CITY PROJECT # 07-24

PALM SPRINGS ANIMAL CARE FACILITY

ADDENDUM NO. 2

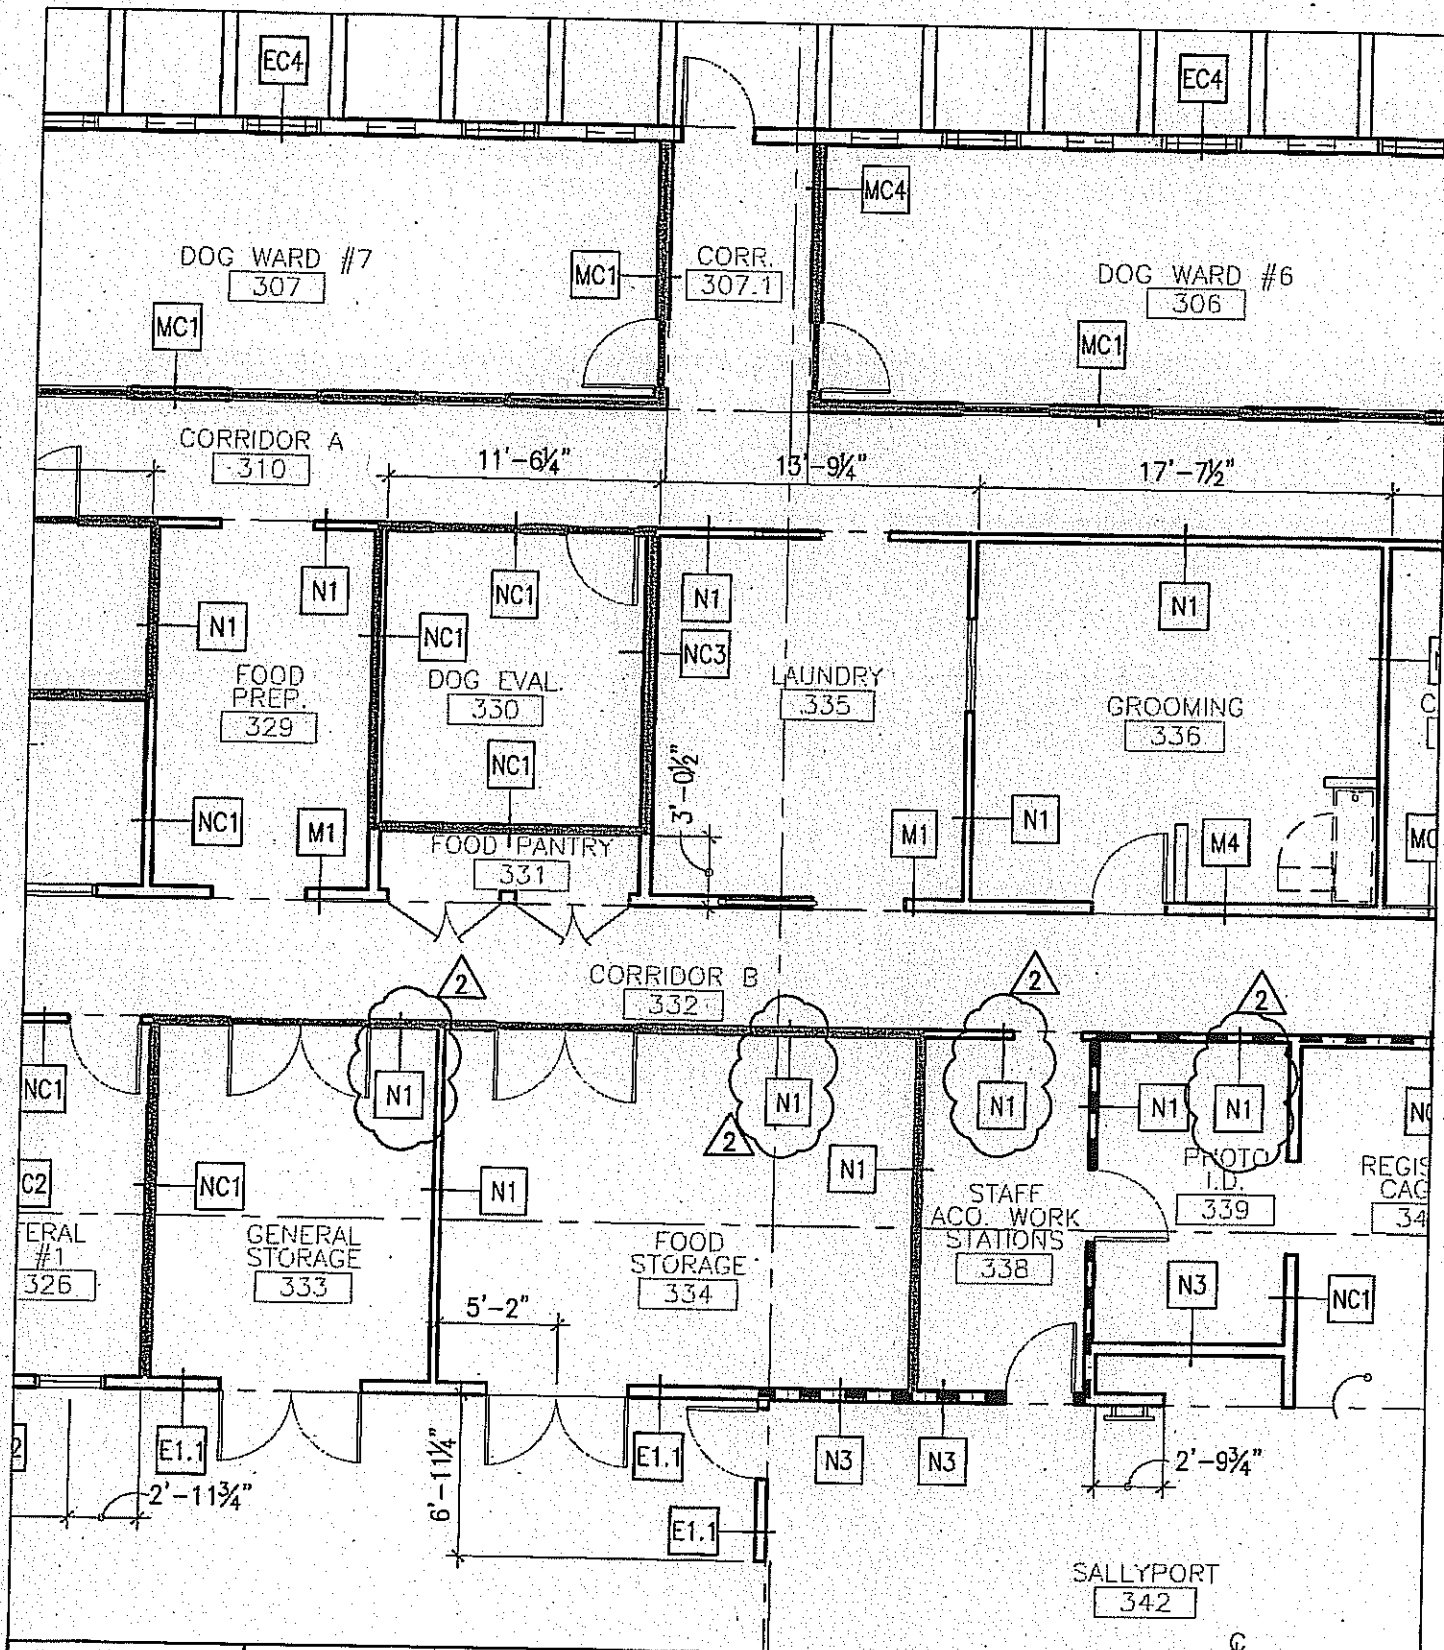
A2-A10 (Reference Drawing A2.01): Revised Wall Types Noted.
